DOD-B-24200B(SH)
AMENDMENT 2
18 March 1986
SUPERSEDING
AMENDMENT 1
22 January 1979

BATTERY CELLS AND ELEMENTS, LEAD-ACID,
LEAD-ANTIMONY, MAIN STORAGE, SUBMARINE;
GENERAL SPECIFICATION FOR (METRIC)

This amendment forms a part of DOD-B-24200B(SH), dated 23 October 1978, and is approved for use within the Naval Sea Systems Command, and is available for use by all Departments and Agencies of the Department of Defense.

FIGURE 2. Self-locking nut, 250°F.

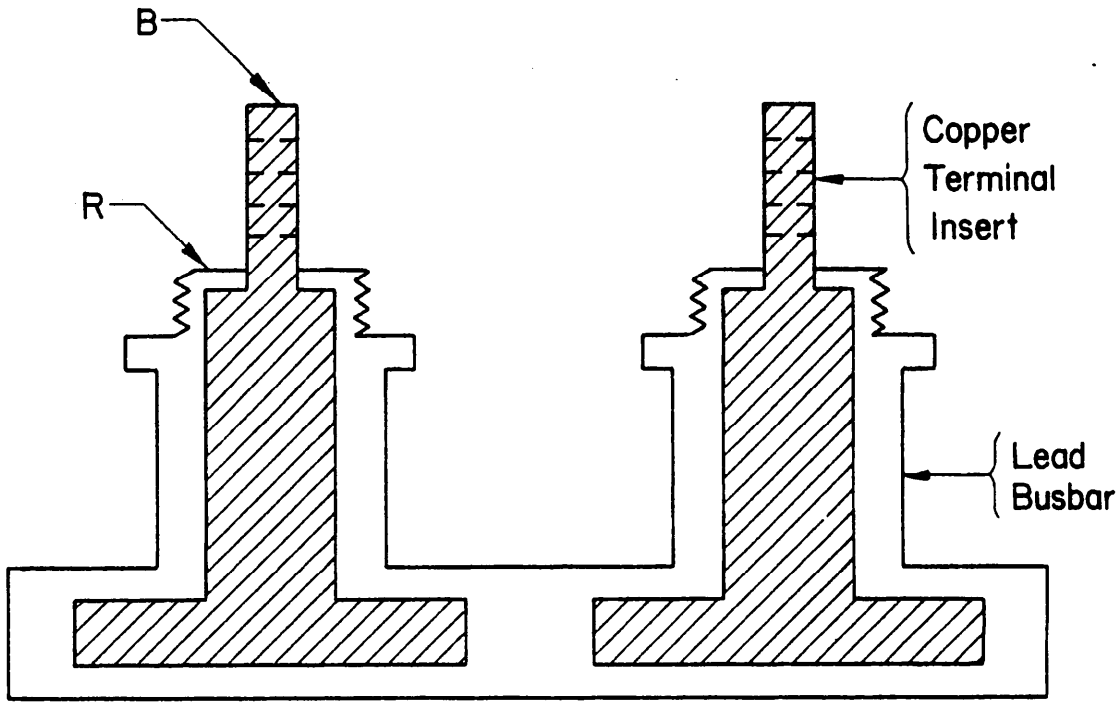
Add as new pages, figures 1 and 2.

NOTES:
1. Nut threads shall be coated with molybdenum disulfide dry film lubricant.
2. Identification: "316" stamped on flat of hex; multiple stamping permissible.
3. Six slots equally spaced collar crimped to form locking feature to meet torque specifications of MIL-N-25027.

FIGURE 1. Terminal resistance measurement.

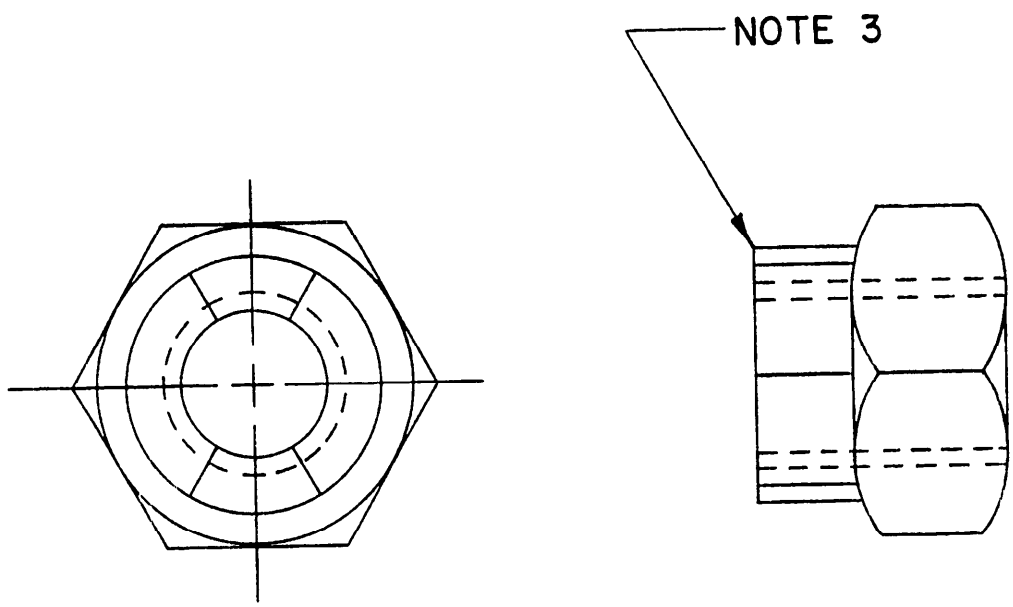
3.3.3.1, first sentence: Add "and figure 1."

4.3.5, lines 2 and 3: Delete "the procedure of NAVSEA S9086-G1-STM-010/CH-223 V1" and substitute "figure 1"."

Measure electrical resistance at points R and B on each terminal of the positive and negative bus bar using a J.W. Dice Company model 150 or 153, or equivalent microohmmeter.
